1. Type of Well S Oil Well Gas Well			8. 1	Well Name and No. FEDERAL 24 2	
2. Name of Operator CHEVRON USA INC	Contact: E-Mail: nglann@cl	NICK GLANN hevron.com		API Well No. 30-025-33779	
3a. Address 6301 DEAUVILLE BLVD MIDLAND, TX 79765		3b. Phone No. (include area code) Ph: 432-687-7786	10.	Field and Pool or Exploratory Are BLINEBERRY, ABO, TUBB	a

# Permanent Abandonment of Federal Wells Conditions of Approval (LPC Habitat)

Proposed Wellbore Diagram

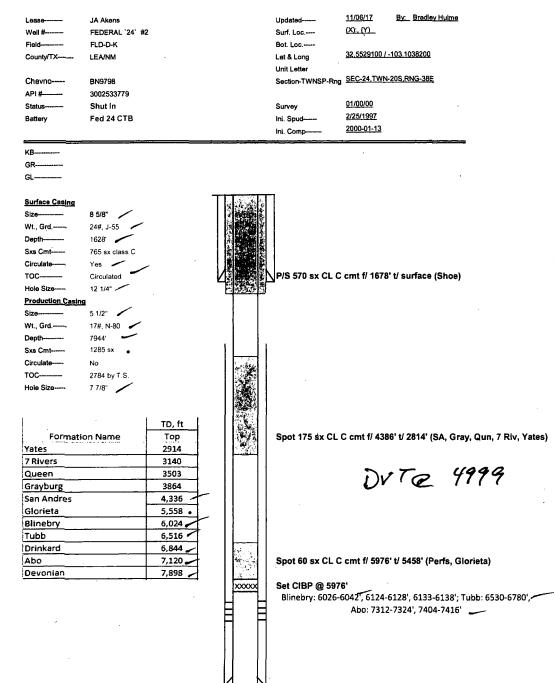
12. CHECK THE	APPROPRIATE BOX(ES)	TO INDICATE NATURE O	F NOTICE, RE	PORT, OR OTHER DATA	<u> </u>
TYPE OF SUBMISSION	<u> </u>	TYPE OF	FACTION	· · · · · · · · · · · · · · · · · · ·	
Notice of Intent	□ Acidize	Deepen	Production		_ -1
—	Alter Casing	Hydraulic Fracturing	Reclamatic		_ rit
Subsequent Report	Casing Repair	New Construction	Recomplet	P&A NR	-
Final Abandonment Notice	Change Plans Convert to Injection	Plug and Abandon Plug Back	Temporari Water Dis	P&A R	-
Chevron respectfully reques	to starting work as per the PE, pull tubing	ollows:	19.	Set 25 SX, Tag om 5049-4900. 8, SQ2 CM+ + 0 14 Tag

2. MIRÚ, pull rods, N/U BOF 3. Set CIBP @ 5976', circula 4. Spot 60 sx CL C cement f	/ 5976' t/ 5458' (Perfs. Glor			•	
<ol> <li>MIRÜ, pull rods, N/U BOF</li> <li>Set CIBP @ 5976', circula</li> <li>Spot 60 sx CL C cement f</li> <li>Spot 175 sx CL C cement</li> <li>Perforate &amp; squeeze 570</li> </ol>	i/ 5976' t/ 5458' (Perfs, Glor f/ 4386' t/ 2814' (SA, Gray) sx CL C cement f/ <del>570' t</del> / si grade, verify cement to sur 'eclamation.	burg, Queen, 7 Rivers, Yates) urface (Shoe, Fresh Water) face, install required dry hole	). WOC & tag / <b>DO ' - S ca</b> / 3 marker as	•

2. MIRÜ, pull rods, N/U BOF 3. Set CIBP @ 5976', circula 4. Spot 60 sx CL C cement f 5. Spot 175 sx CL C cement 6. Perforate & squeeze 570 7. Cut off wellhead 3' below per COAs, and turn over to r Bulew ground	/ 5976' t/ 5458' (Perfs, Glor f/ 4386' t/ 2814' (SA, Gray) sx CL C cement f/ <del>570' t</del> / sr grade, verify cement to sur reclamation.	burg, Queen, 7 Rivers, Yates) burgace (Shoe, Fresh Water) face, install required dry hole	. WOC & tag /DO'-Sura marker as	e>	₽
<ol> <li>MIRÜ, pull rods, N/U BOF</li> <li>Set CIBP @ 5976', circula</li> <li>Spot 60 sx CL C cement f</li> <li>Spot 175 sx CL C cement f</li> <li>Perforate &amp; squeeze 570.</li> <li>Cut off wellhead 3' below</li> </ol>	/ 5976' t/ 5458' (Perfs, Glor f/ 4386' t/ 2814' (SA, Gray) sx CL C cement f/ <del>570' t</del> / si grade, verify cement to sur reclamation. <u>ecce</u> <u>ary</u> <u>hot</u> is true and correct. Electronic Submission # For CHE	burg, Queen, 7 Rivers, Yates) urface (Shoe, Fresh Water) face, install required dry hole	WOC & tag	EE ATTACHED FOI	₽
